Field Report

The Park Danforth **Project No:** 13-059-00
Portland ME **Field Report No:** 12

Mock up wall

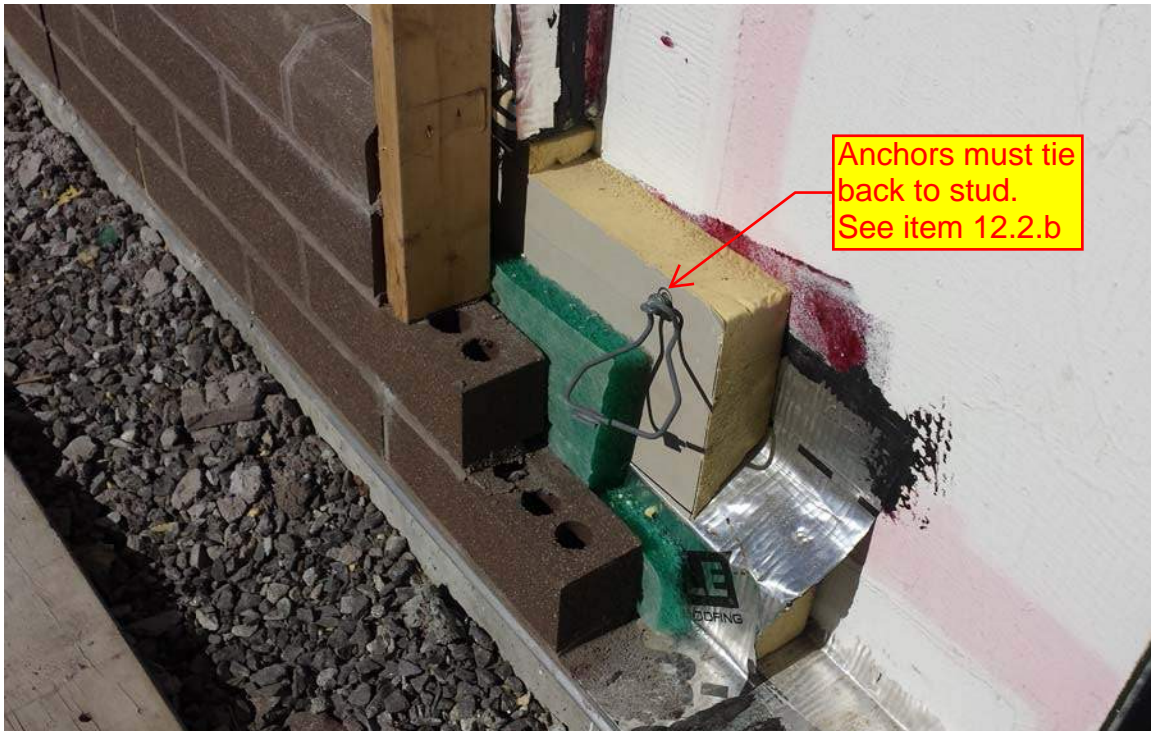
Anchors must tie back to stud.
See item 12.2.b

Mock up wall at lintel

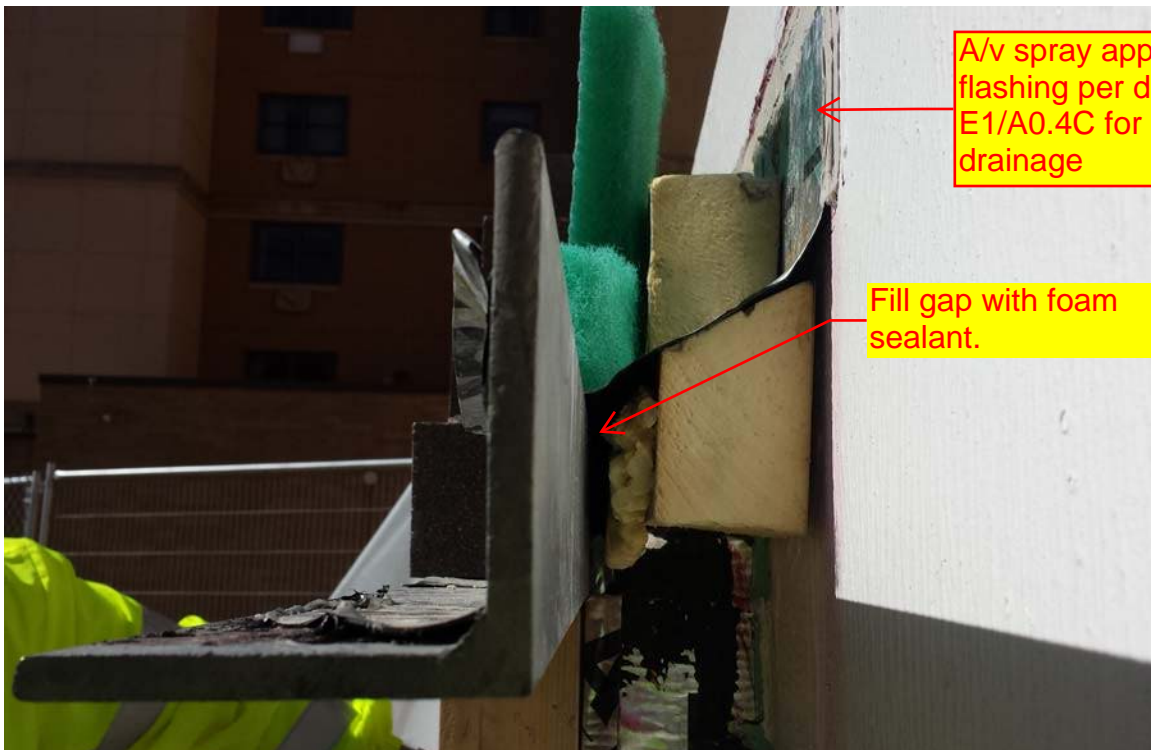
A/v spray applied over flashing per detail E1/A0.4C for positive drainage

Fill gap with foam sealant.

Level 5 of tower garden roof deck

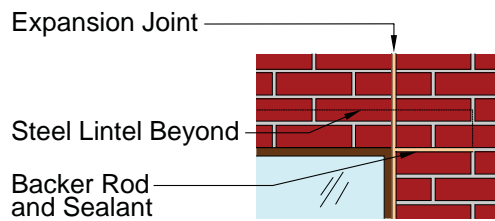
12.10	Wire mesh in the concrete at the 5th floor garden roof deck is exposed in some areas. See Photo A P17 of 18	Correct Work
12.2	<u>MOCK UP WALL</u>	Correct Work
	<ul style="list-style-type: none"> a. Flashings at lintel shall extend the full length of the lintel per 04 20 00-3.14. See Photo B P3 of 19 b. Brick ties shall be secured to stud framing per 04 20 00-3.12E. See photo A P4 of 18 c. Control joints at masonry openings shall be constructed in accordance with the Brick Industry Associations TN 18A, Figure 6 (see attachment 1 for reference)

EXPOSED WIRE MESH AT ROOF DECK. SEE ITEM 12.10

Figure 6**Expansion Joint at Loose Lintel**

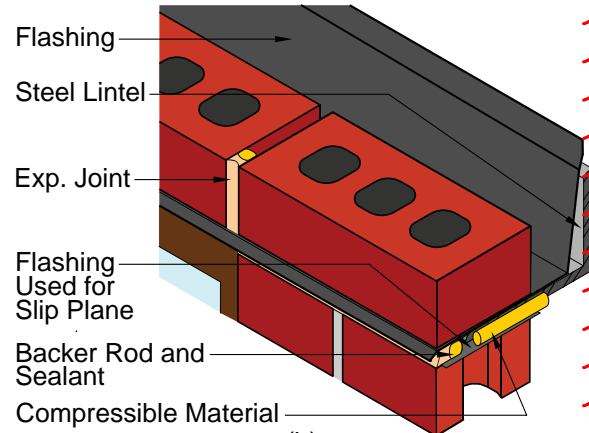
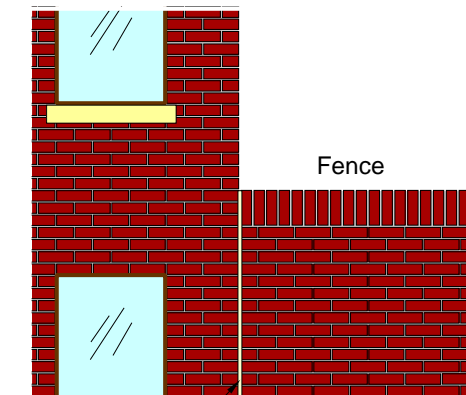
If a vertical expansion joint runs alongside an opening spanned by a loose lintel as shown in **Figure 6a**, the loose steel lintel must be allowed to expand independently of the masonry. A slip plane should be formed by placing flashing above and below the angle. Mortar placed in front of the lintel is subject to cracking; thus, a backer rod and sealant should be used, as shown in **Figure 6b**. Because steel expands more than masonry, a $\frac{1}{8}$ to $\frac{1}{4}$ in. (3.2 to 6.4 mm) space should be left at each end of the lintel. These measures form a pocket that allows movement of the steel angle within the brickwork. Locating the expansion joint adjacent to the window will influence the dead weight of the masonry bearing on the lintel. Instead of the usual triangular loading, the full weight of the masonry above the angle should be assumed to bear on the lintel. See *Technical Note 31B* for more information about steel lintel design. If a vertical expansion joint cannot be built in this manner, do not place it alongside the opening.
